PLANNING REPORT

Architectural Review Board

Laird Residence 24-161INF

Address	273-013558
Proposal	Request for informal review and feedback for the construction of a new single-family home in the Historic District.
Request	Informal review and feedback on new construction.
Zoning	HD-HR, Historic Residential District
Planning Recommendation	<u>Consideration of the discussion questions.</u>
Next Steps	Upon receiving feedback from the Architectural Review Board (ARB), the applicant may incorporate the feedback and submit for Minor Project Review.
Applicant	Taylor Sommer, His and Hers Architects
Case Manager	Sarah Tresouthick Holt, AICP, ASLA, Senior Planner (614) 410-4662 sholt@dublin.oh.us

Front Façade

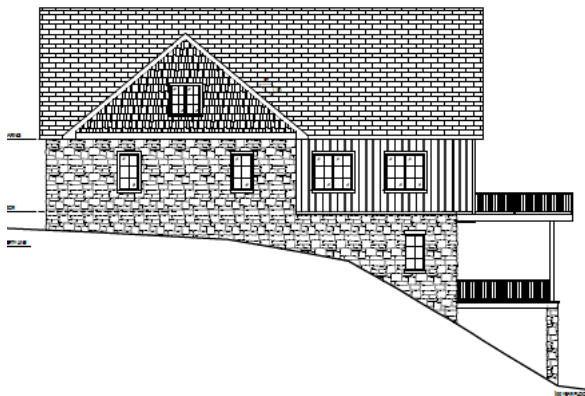
The applicant shows a 1½ story front façade facing S. Riverview, with a 2½ story façade facing the river. Massing along the front façade is simple, traditional, and vernacular and meets Guidelines 5.0 and 5.1B which note the need to respond to the height, massing, setbacks, form, and fenestration of the surrounding Landmark context. A projecting, centered front gable with simple columns delineates the front door. Window spacing and proportions appear appropriate at this stage per Guidelines 5.6, and trim, sills, and lintels are present as required by Code. The upper shed-roof dormer window should include mullions between the individual windows for a more traditional design. The Board is requested to comment on front massing.

North Façade (blue sunroom adjustment, see below)

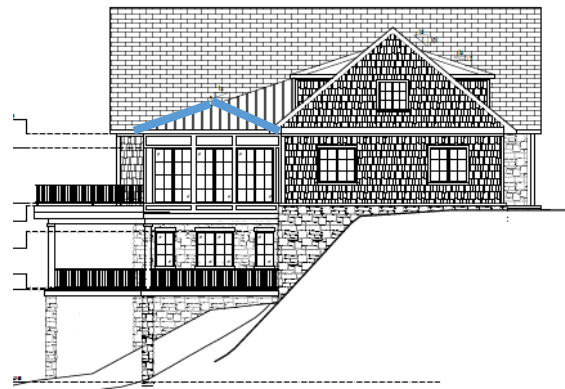
The side-facing façades and roof forms generally step down the slope, as encouraged by Guidelines 5.3D. A hipped gable form could be considered to address this more. These façades also show appropriate window spacing and proportions, although the windows on the south side may be too small for the mass of the façade. All double windows should have mullions between them for a more traditional appearance. The applicant may consider extending the stone foundation to the window sill levels. Two stories of decks are seen projecting toward the river. The Board is requested to comment on these elevations.
